DOCKETED	
Docket Number:	24-OPT-05
Project Title:	Corby Battery Energy Storage System Project
TN #:	272509
Document Title:	Sarah Dunn Comments - Alternatives Analysis on Lambie Industrial Park is Insufficient
Description:	N/A
Filer:	System
Organization:	Sarah Dunn
Submitter Role:	Public
Submission Date:	9/10/2026 2:33:22 PM
Docketed Date:	9/10/2026

Alternatives Analysis on Lambie Industrial Park is Insufficient

RE: Comments on the Staff Assessment / Draft Environmental Impact Report for the Corby Battery Energy Storage System Project (Docket No. 24-OPT-05) – Inadequacy of the Alternatives Analysis Regarding the Lambie Industrial Park Site and Alternative Interconnection Points

6246 Lambie Rd

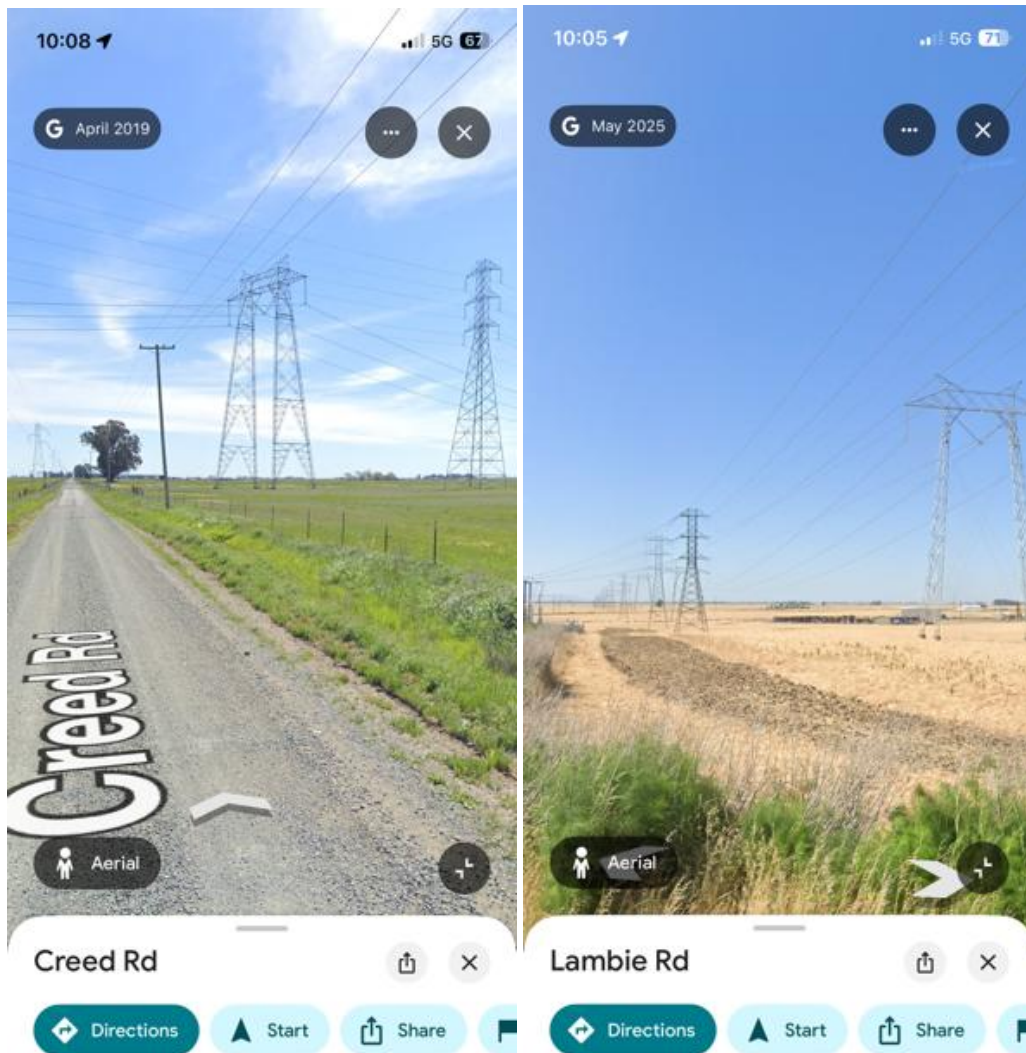
Throughout the alternatives analysis, the SA/DEIR repeatedly asserts that the Lambie Industrial Park site consists of “rolling hills” and would consequently require substantially greater grading and earthwork, leading to higher environmental impacts. **This factual assertion is entirely incorrect.**

A review of the administrative record reveals a fundamental conflation of distinct alternative sites by CEC Staff. In the applicant's Data Requests regarding alternatives, Staff requested an evaluation of two distinct locations: (1) Lambie Industrial Park, and (2) the Montezuma Wind Facility site (where the applicant maintains an existing wind project). While the Montezuma Hills site is indeed located on rolling terrain that would require extensive earthwork and grading, the Lambie Industrial Park site is topographically flat.

By mistakenly conflating the topographic profile and grading requirements of the Montezuma site with Lambie Industrial Park, CEC Staff constructed a flawed comparative environmental baseline. This material factual error directly compromised Staff's evaluation of air quality, noise, hydrological, and soil disturbance impacts for Lambie. More critically, this fundamental error raises significant questions regarding what other factual inaccuracies and unverified assumptions exist within Staff's comparative assessment.

What specific topographic data, USGS quadrangle maps, or elevation surveys did CEC Staff rely upon when concluding in the SA/DEIR that Lambie Industrial Park consists of "rolling hills" requiring substantial grading?

1. Does the lead agency acknowledge that Staff inadvertently conflated the physical topographic attributes of the Montezuma Wind Facility site with those of the flat, industrially zoned Lambie Industrial Park site?
2. Given that Lambie Industrial Park is flat and does not require the extensive cut-and-fill grading asserted in the SA/DEIR, how does CEC Staff intend to recalculate and correct the comparative air quality, dust generation, public health, greenhouse gas emissions, heavy equipment fuel consumption, and earthwork impact determinations in a revised SA/DEIR?
3. In light of this material error in physical site characterization, what process will the Commission undertake to re-evaluate whether Lambie Industrial Park is, in fact, the Environmentally Superior Alternative under CEQA Guidelines § 15126.6(e)(2)?

3. Correct the factual record regarding Lambie Industrial Park's flat topography and re-evaluate grading, dust, public health, greenhouse gas emissions and earthwork impact comparisons.
